## ENGINEERING CHANGE NOTICE

1. ECN ~~142704~~  
 Proj. ECN B-714-84

Block 5: B-714, Grout Vault Pair (218-E-16-102 & 103)(218-E-16-104 & 105)/ER8007

ECN No. B-714-84	Page 7/ 11	
Ref. Dwg. SPEC B-714-C2	Sh.	Rev. 1
Prep. By H. J. STEFFENS	Ckd. By PC RARRINS

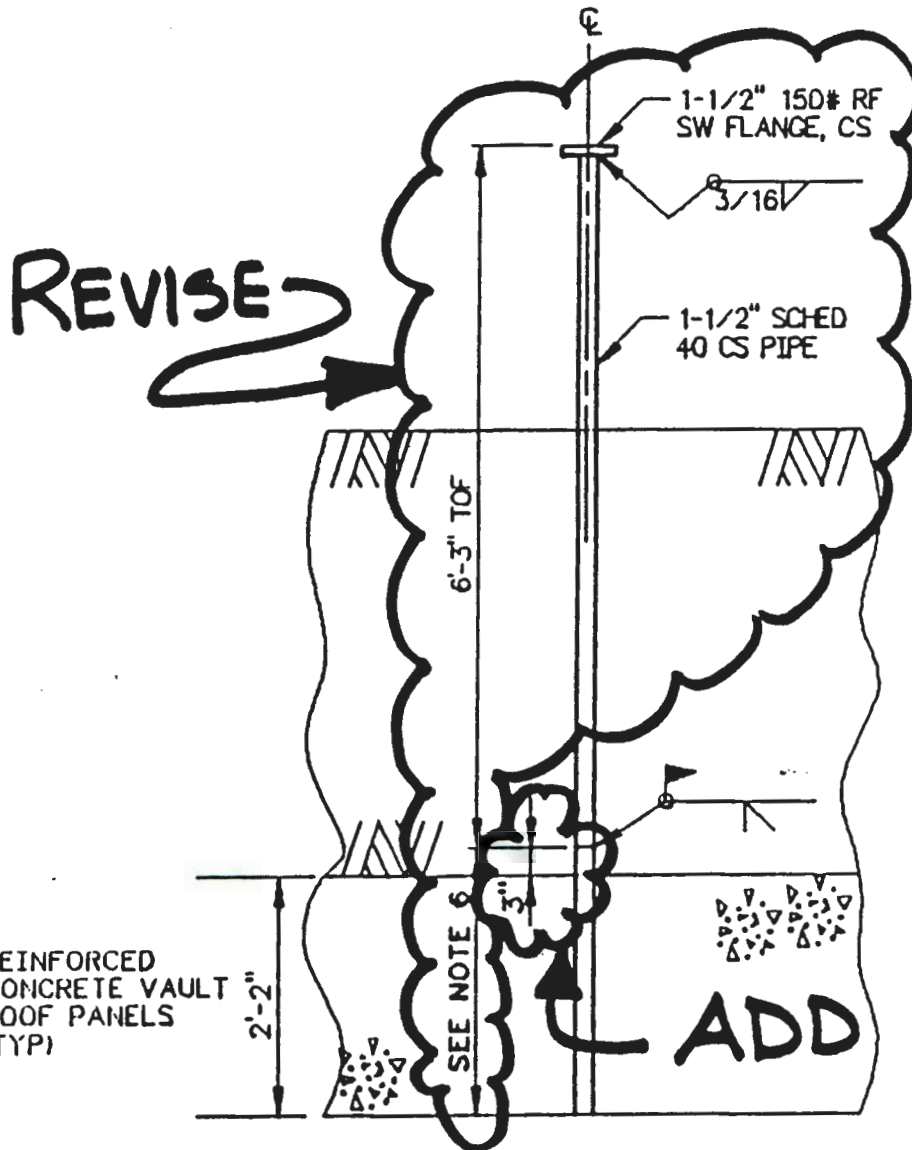
2. Delete Data Sheet Y-102 and replace with new Data Sheet Y-102 as shown on page 6 & 7 of this ECN.

- NOTES:
- |    |   |  |  |

| 1. | Tag Numbers and Cable Length + Cable Length + 12 inches, -0 inches                          | TE-102-1-150FT<br>TE-102-2-150FT<br>TE-102-3-130FT<br>TE-102-4-130FT<br>TE-104-1-150FT<br>TE-104-2-150FT<br>TE-104-3-130FT<br>TE-104-4-130FT | TE-103-1-200FT<br>TE-103-2-150FT<br>TE-103-3-130FT<br>TE-103-4-80FT<br>TE-105-1-200FT<br>TE-105-2-150FT<br>TE-105-3-130FT<br>TE-105-4-80FT |
| 2. | See Drawings  |  |  |
| 3. | Thermocouple Probe Assembly shall have a minimum service life of 30 years under normal use. |  |  |

Ref. Dwg. H-2-77619	Sh. 1	Rev. 1	Prepared By TK EHRHARD	Checked By PC BARROUS	ECN No. B-714-84	Page 8/11
H-2-78491	1	1

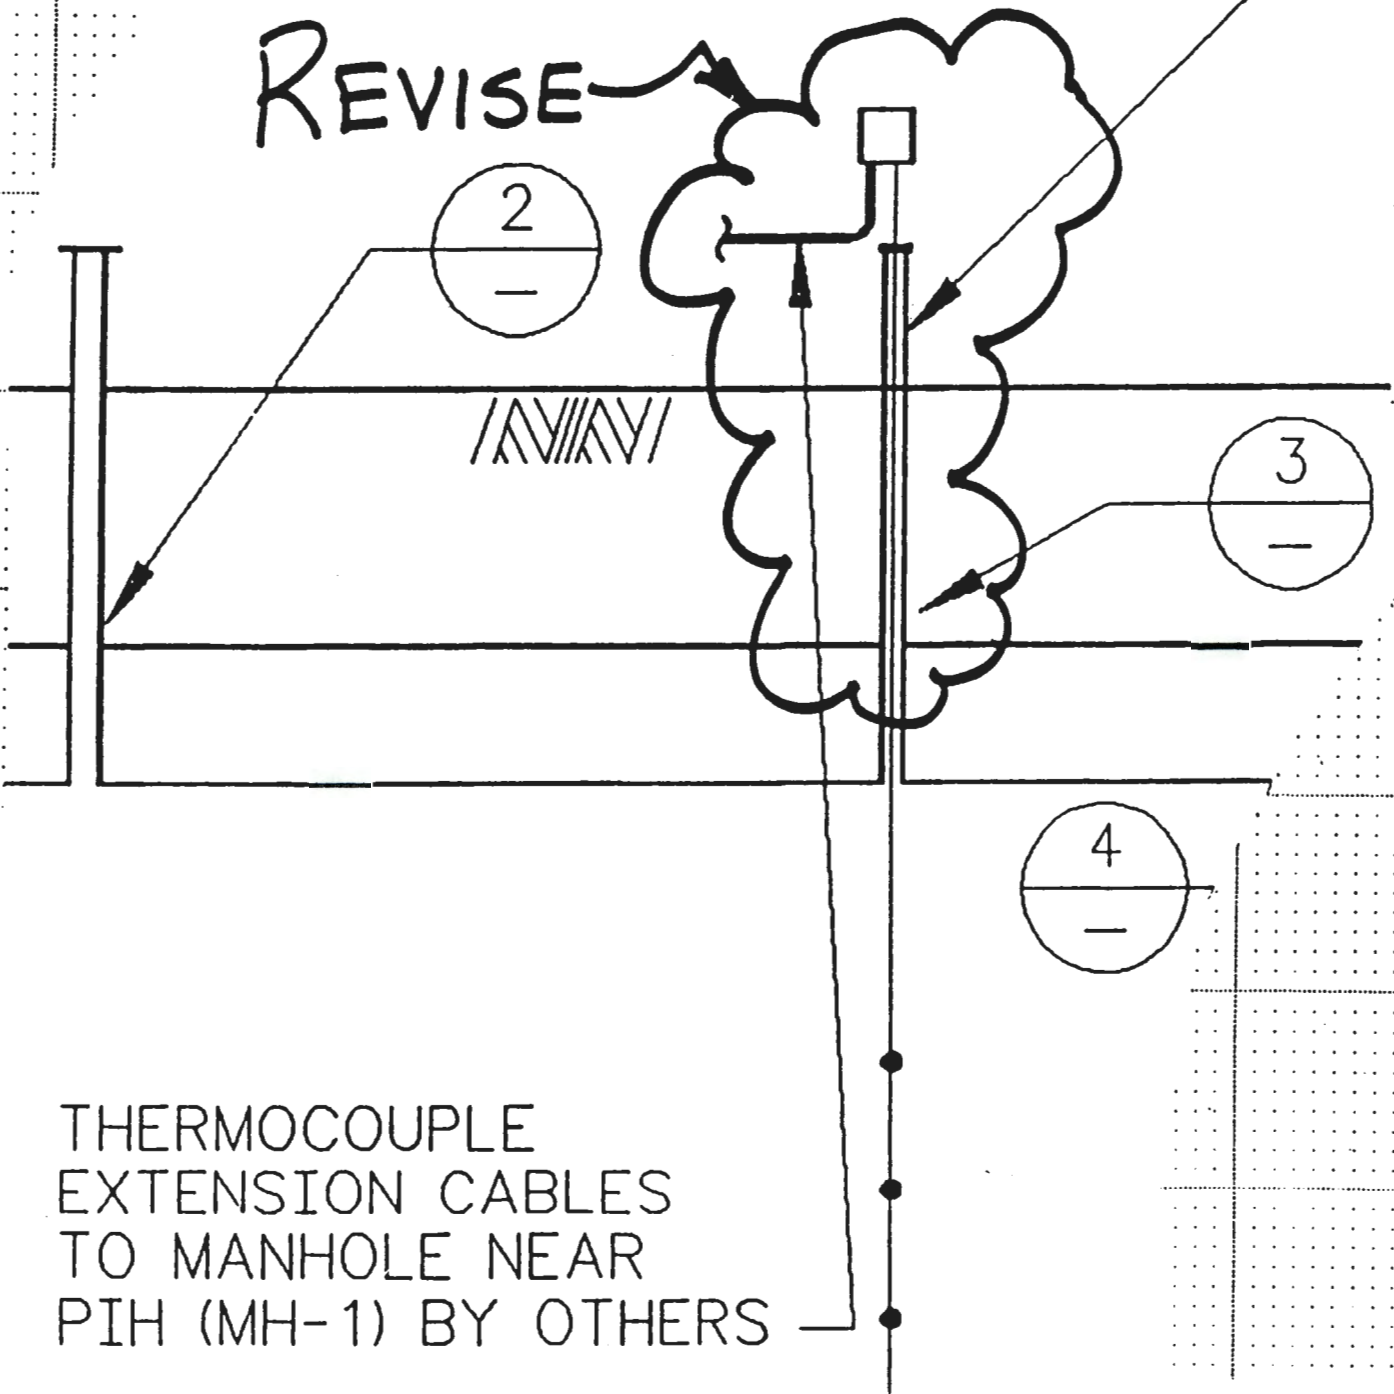
- A) DETAIL 3 (Z E4): Extend riser as shown on page 8 of this ECN.
- B) SECTION A (Z C6): Modify probe assy as shown on page 9 of this ECN.
- C) NOTE 6: Change to read as follows -  
RISER #42 AND #45 MEASURED FROM BOTTOM OF CORBEL. LENGTH = 2'-11" WITH 3" EXTENSION ABOVE ROOF PANEL. RISER #43 AND #44 LENGTH = 2'-5" WITH 3" EXTENSION.

- A) DETAIL 3 (Z E4): Extend riser as shown on page 8 of this ECN.
- B) SECTION A (Z C6): Modify probe assy as shown on page 9 of this ECN.
- C) NOTE 6: Change to read as follows -  
RISER #42 AND #45 MEASURED FROM BOTTOM OF CORBEL. LENGTH = 2'-11" WITH 3" EXTENSION ABOVE ROOF PANEL. RISER #43 AND #44 LENGTH = 2'-5" WITH 3" EXTENSION.

**DETAIL**

SCALE: 3/4" = 1'-0"  
THERMOCOUPLE PROBE  
PENETRATION RISER  
SEE NOTE 2 & 3

Ref. Dwg.	Sh.	Rev.	Prepared By	Checked By	ECN No.	Page
H-2-77620	1	0	GF MCKEE	PC BARROWS	B-714-84	10/11
H-2-78492	1	0

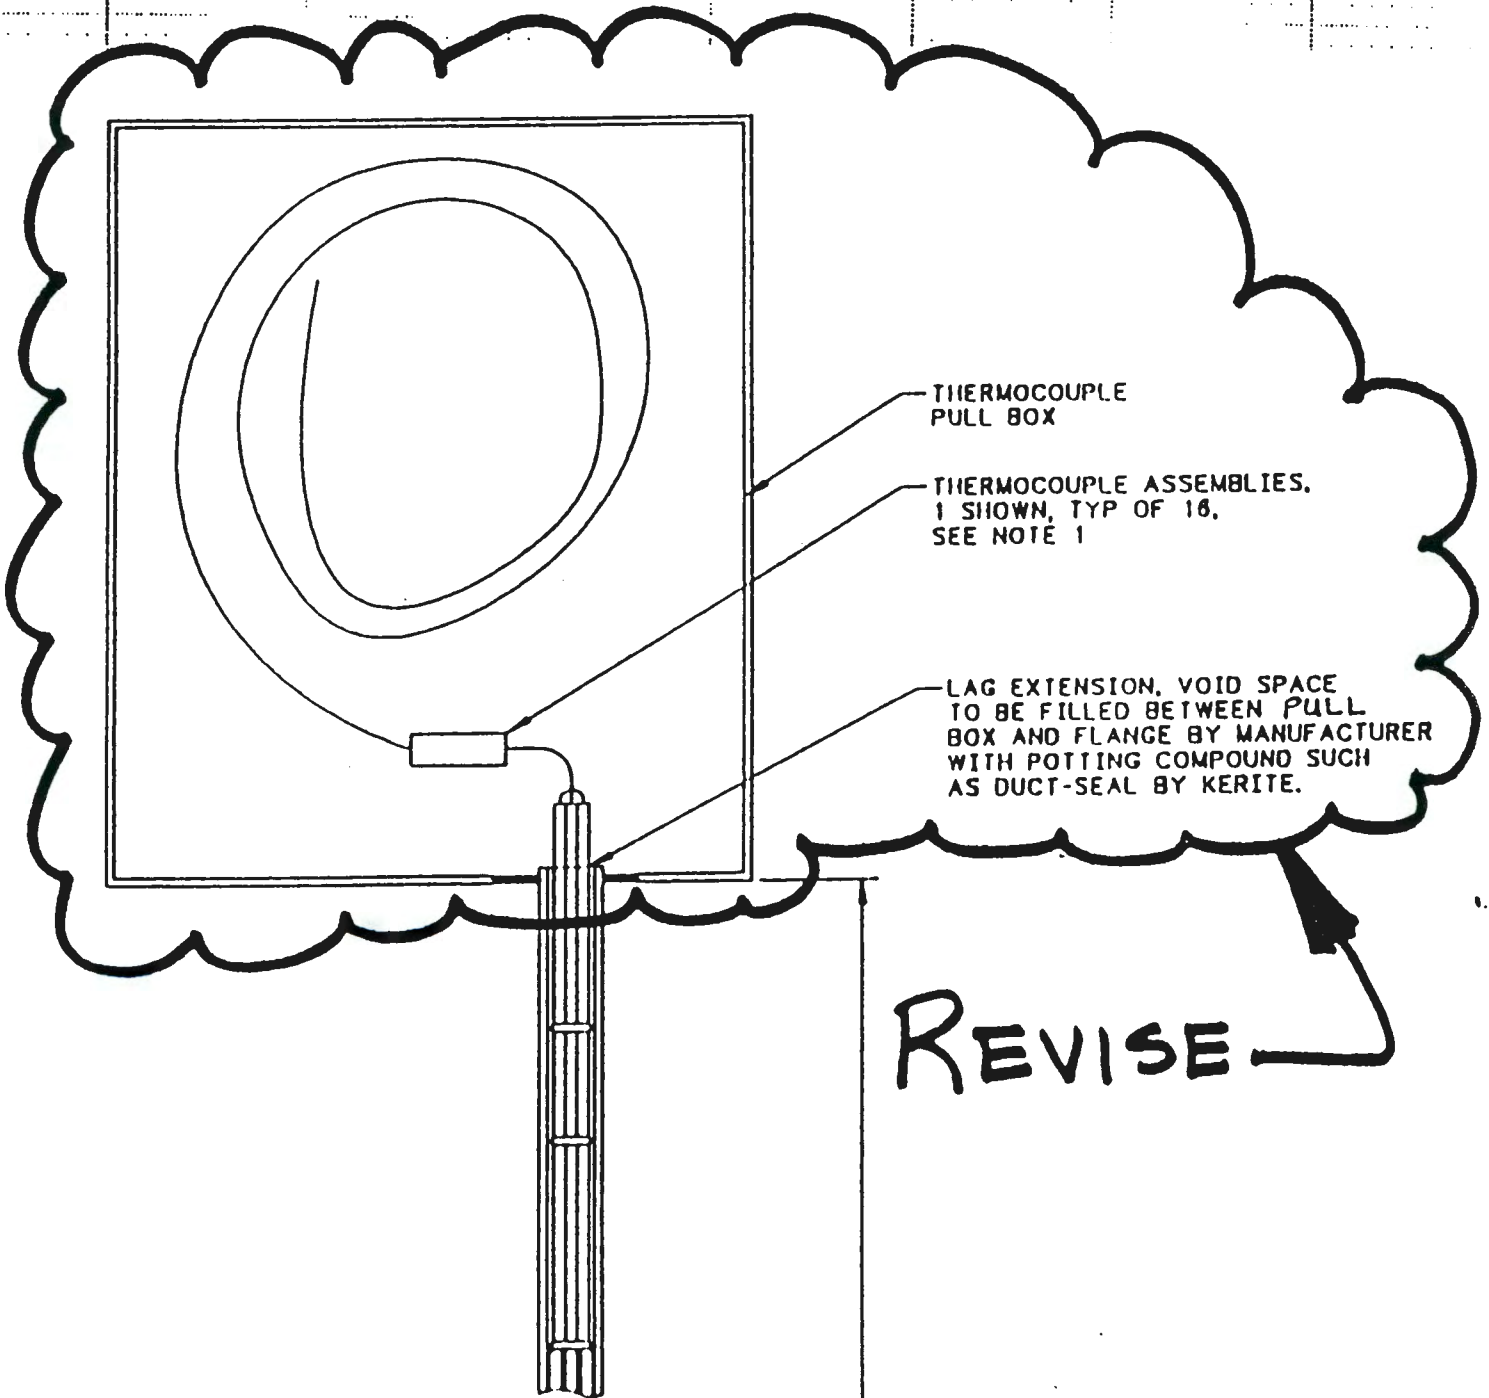
- A) ASSEMBLY (Z E4-F5, C4):
  - 1. Change junction box to pull box as shown on page 10 of this ECN.
  - 2. Change PROBE INSERTION LENGTH to read 43'-6".
- B) Change Note 3 to read THERMOCOUPLE ASSEMBLIES AS SUPPLIED BY VENDOR SHALL HAVE PROTECTION TUBE. THERMOCOUPLE PULL BOX SHALL BE SUITABLE FOR BURIAL.
- C) DELETE Note 6 in its entirety.

- A) ASSEMBLY (Z E4-F5, C4):
  - 1. Change junction box to pull box as shown on page 10 of this ECN.
  - 2. Change PROBE INSERTION LENGTH to read 43'-6".
- B) Change Note 3 to read THERMOCOUPLE ASSEMBLIES AS SUPPLIED BY VENDOR SHALL HAVE PROTECTION TUBE. THERMOCOUPLE PULL BOX SHALL BE SUITABLE FOR BURIAL.
- C) DELETE Note 6 in its entirety.
